**DEPARTMENT OF TRANSPORTATION  
STATE OF GEORGIA**

**FILE** P. I. No. 110680-, Banks/Franklin Counties **OFFICE** Preconstruction  
NH-IM-85-2(172)  
I-85 Widening from North of SR 63 **DATE** April 9, 2008  
To North of SR 51

**SUBJECT** APPROVED REVISED PROJECT CONCEPT REPORT

**SUBJECT** Revised Project Concept Report

STATE OF GEORGIA  
DEPARTMENT OF TRANSPORTATION  
OFFICE CONSULTANT DESIGN  
TYPICAL SECTIONS

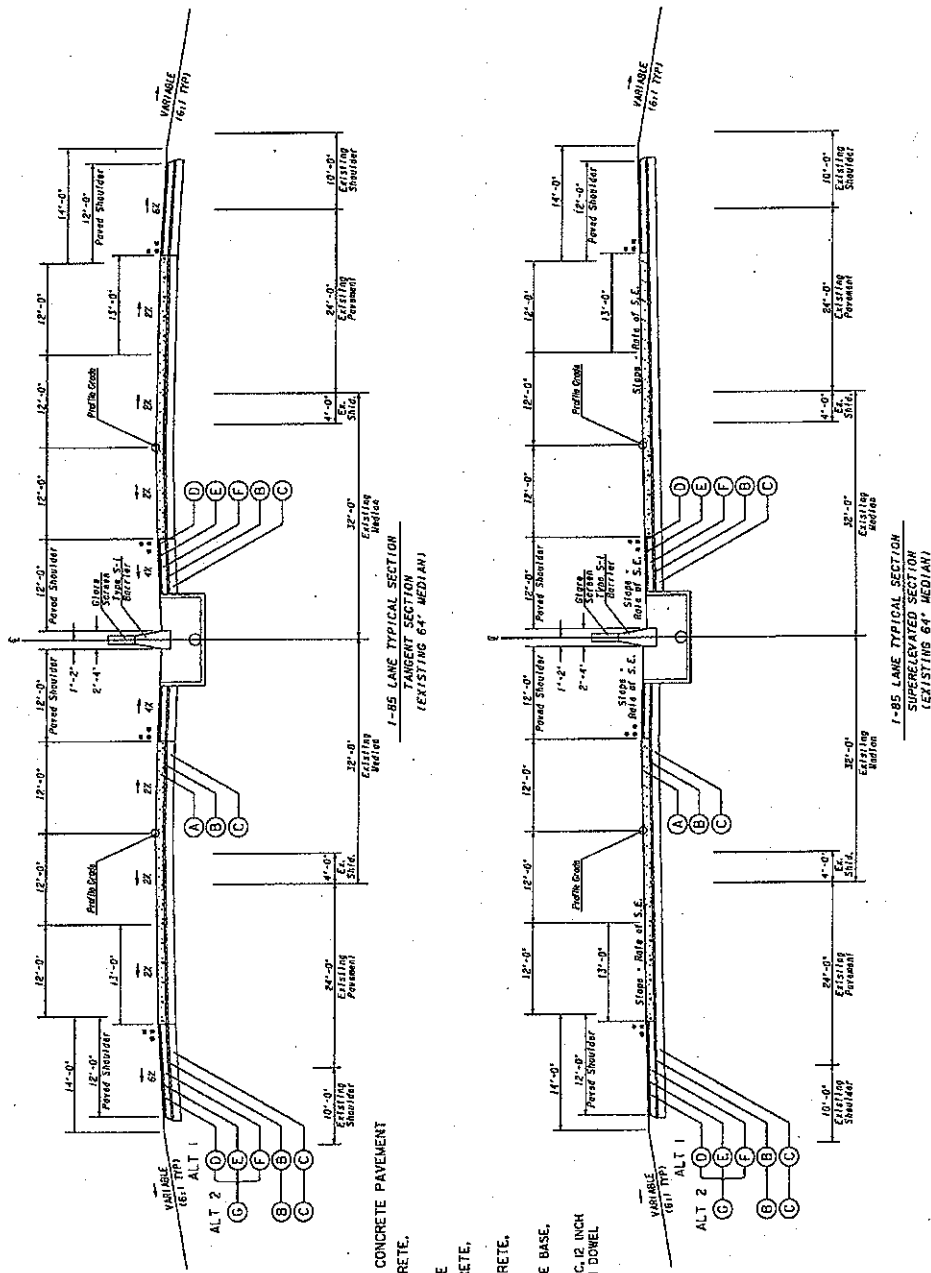
The typical section will be revised to decrease the inside and outside paved shoulder widths per agreement with FHWA. The revised typical section will begin on I-85 just north of SR 63 and extend throughout the project corridor, ending just north of SR 51.

- **The revised typical section:**  
Mile log 154.3-160.0
  - Six 12' lanes, outside lane paving will extend 1'-0" into the paved outside shoulder but will be striped at 12'-0"
  - Median Barrier (Type S-1, S-2 or S-3)
  - 13'-2" inside shoulder (12' paved)
  - 14' outside shoulder (12' paved), includes 1'-0" extension of outside lane pavement
  - Concrete pavement section with full depth reconstruction of existing pavement and an alternative pavement section (asphalt or concrete) for the paved shoulders

The revised typical section will begin on I-85 just north of SR 63 and extend throughout the project corridor, ending just north of SR 51.
